{ Denotes changes to ADD. 98 - 10/15/76 CO ADD. 98 - 5/5/77

H-1 VIADUCT (WB)

INDEX TO DRAWINGS
ESTIMATED QUANTITIES

KEEHI INTERCHANGE
F.A.I. PROJ. NO. I-HI-1 (130): 17

LONGITUDINAL BRACING DETAIL
Scale: 1/4" = 1'-0"

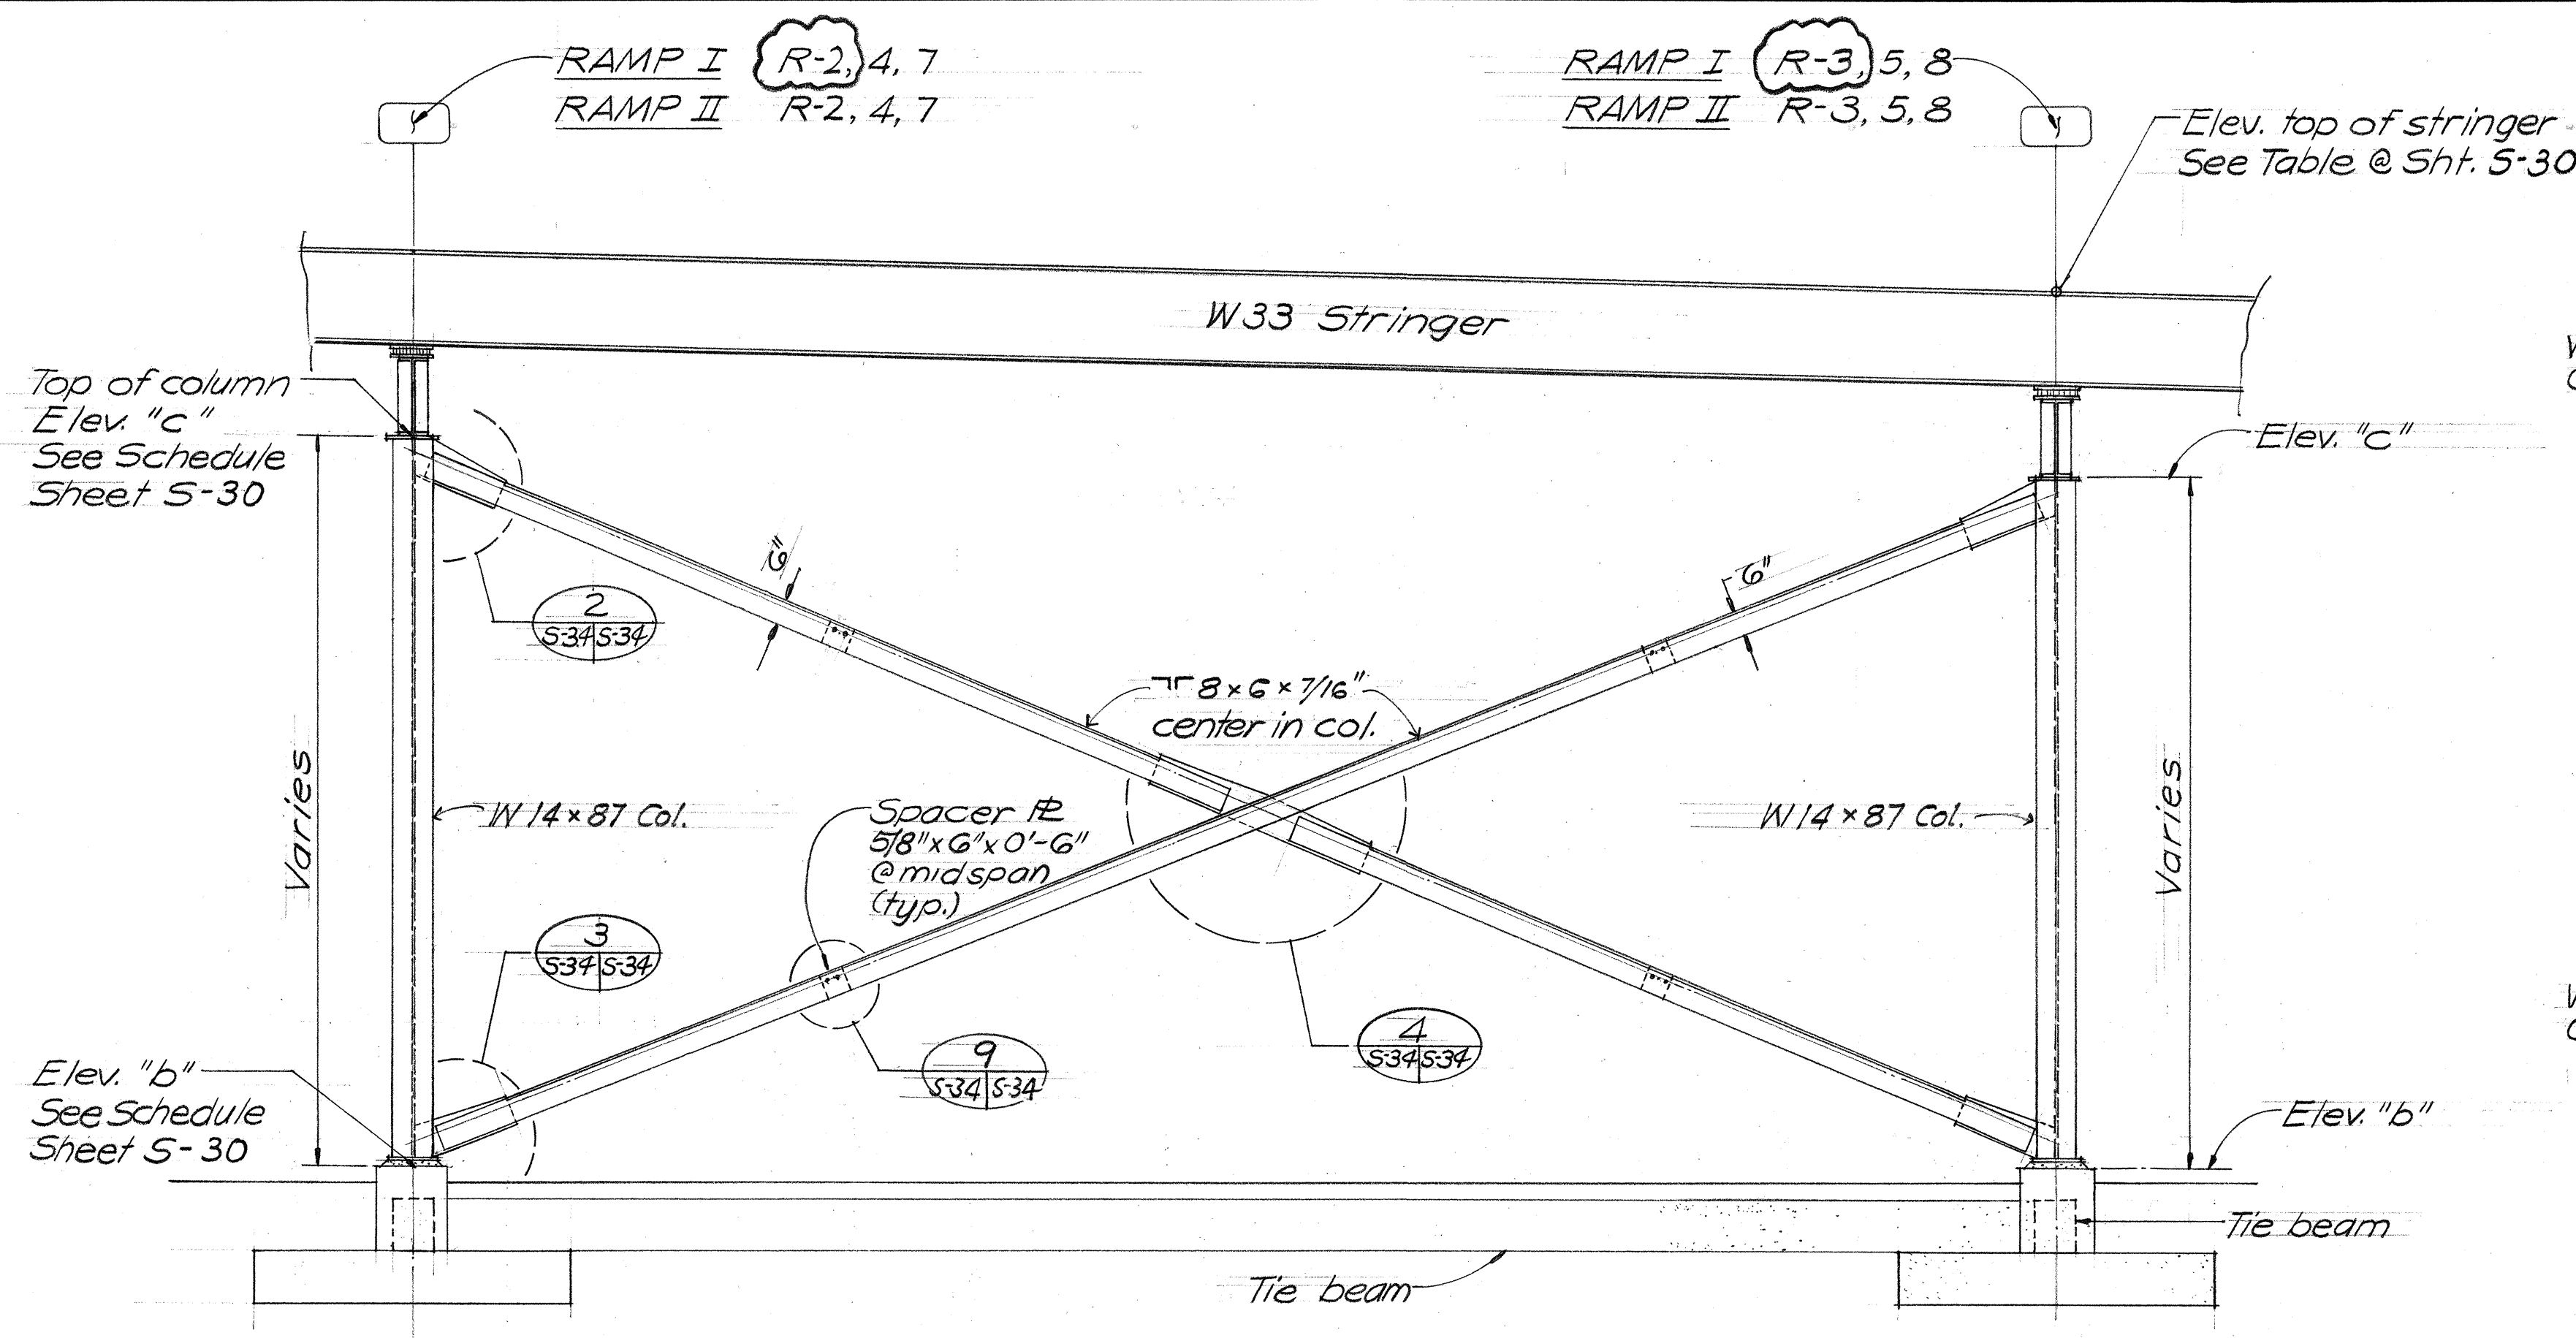
10/15/76	Revised longitudinal bracing to correct bay.
DATE	REVISION

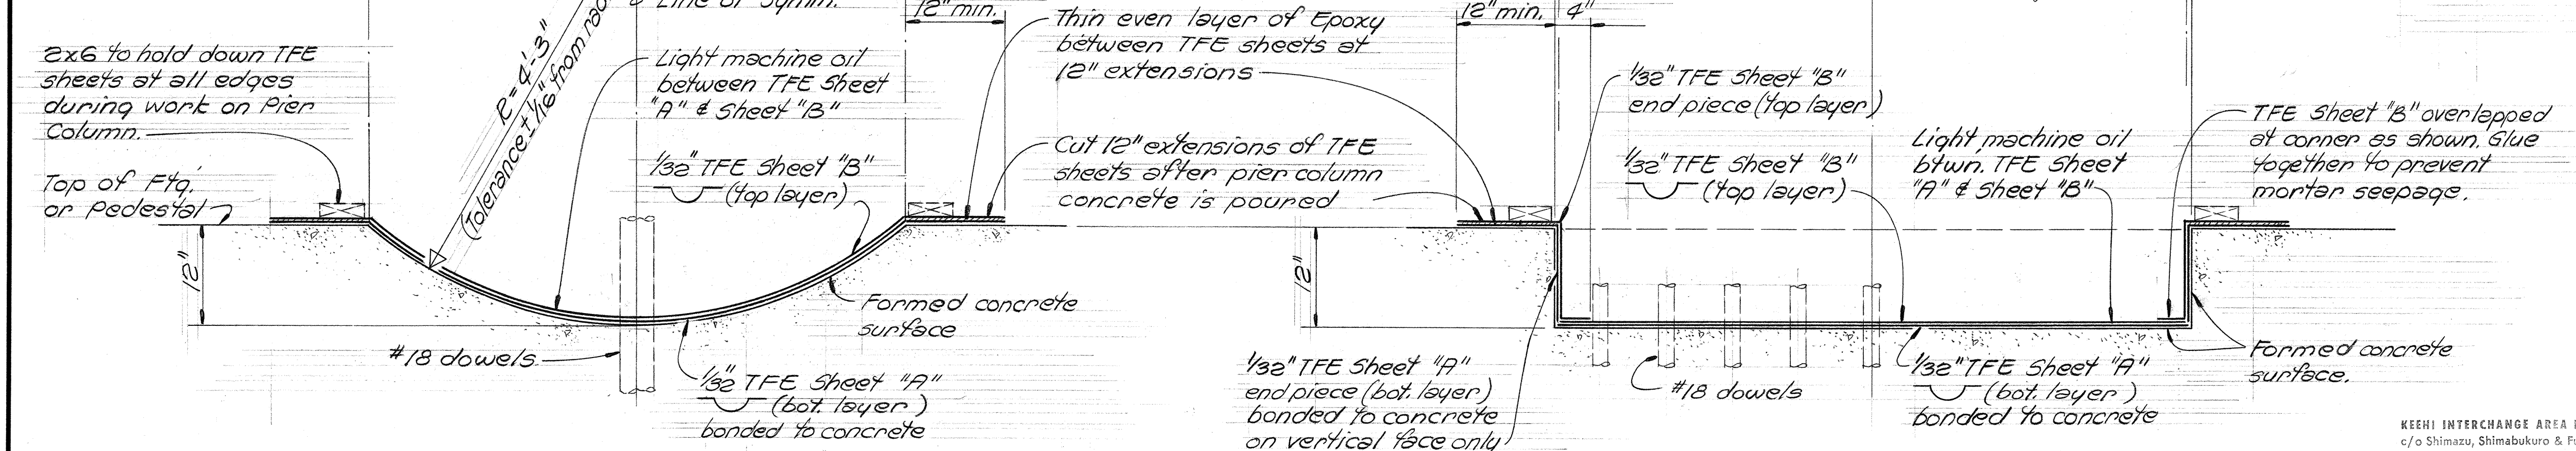
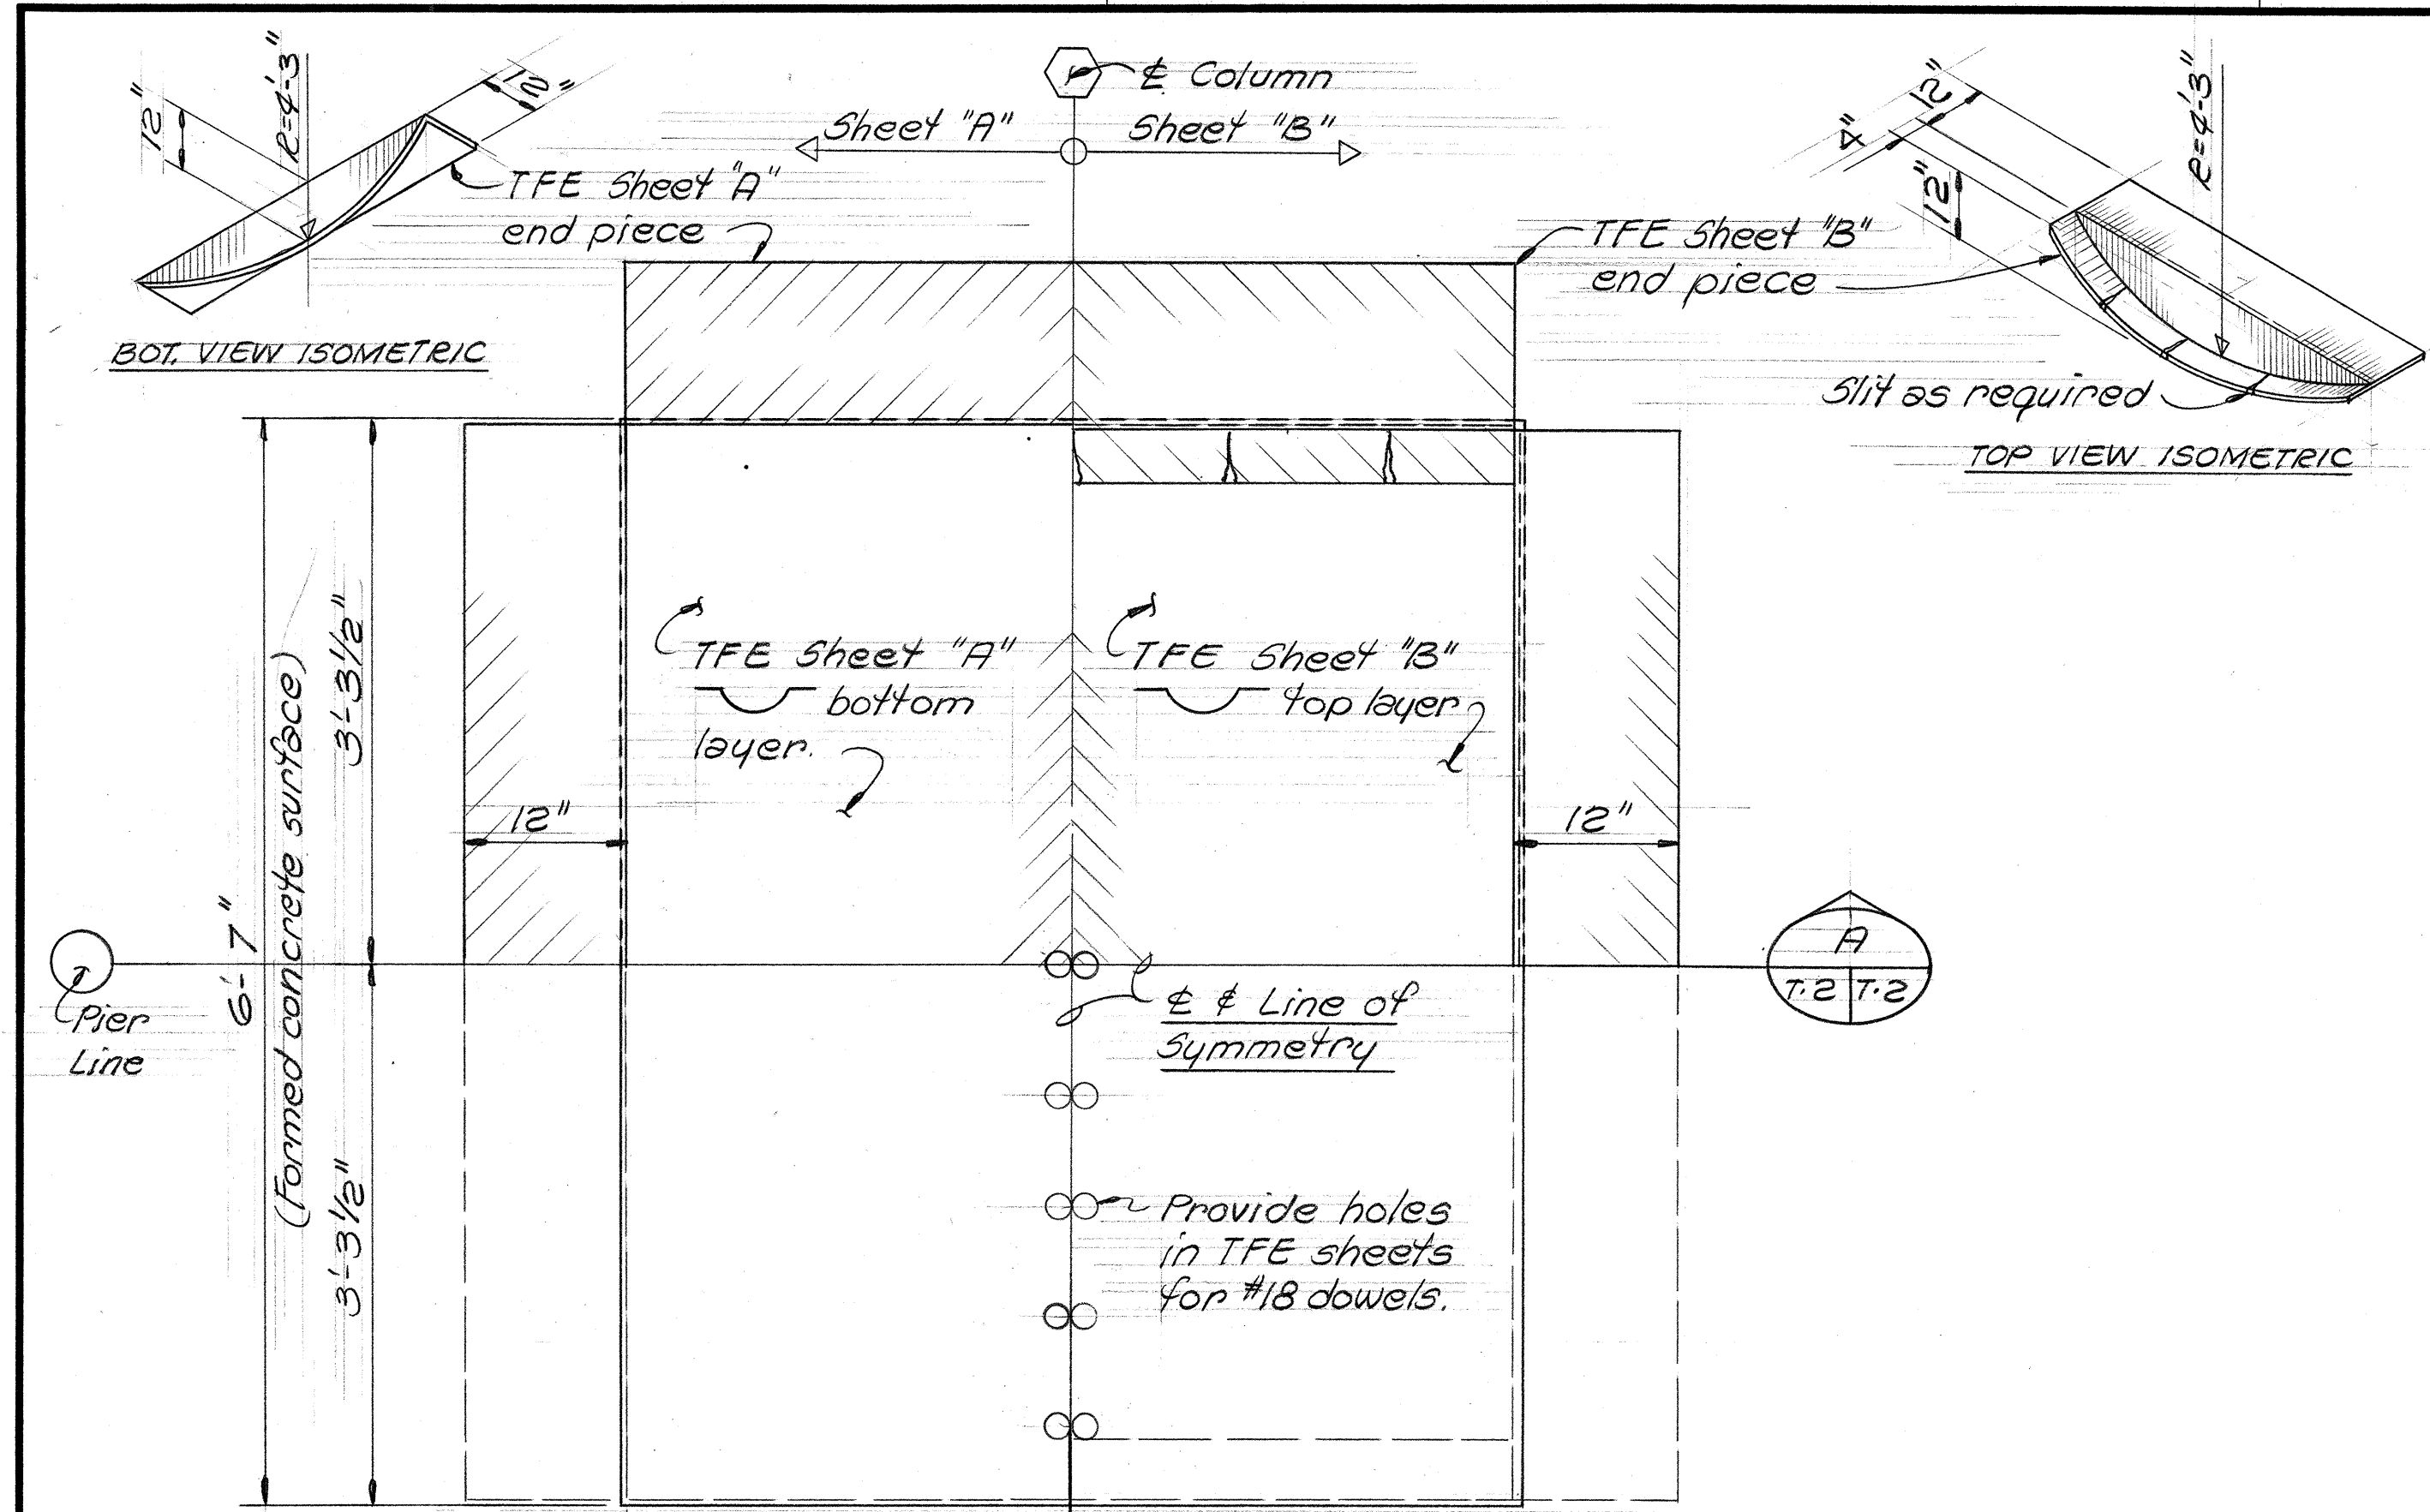
DATE	REVISION
10/15/76	Revised Column Hinge & Notes
STATE OF HAWAII DEPARTMENT OF TRANSPORTATION HIGHWAYS DIVISION	
TYPICAL DETAIL	
COLUMN HINGE DETAILS	
KEEHI INTERCHANGE F.A.I. PROJ. No. IHI-1(130)117	
Scale: As Shown	Date: Aug. 16, 1976
SHEET NO. T.2 OF 20 SHEETS
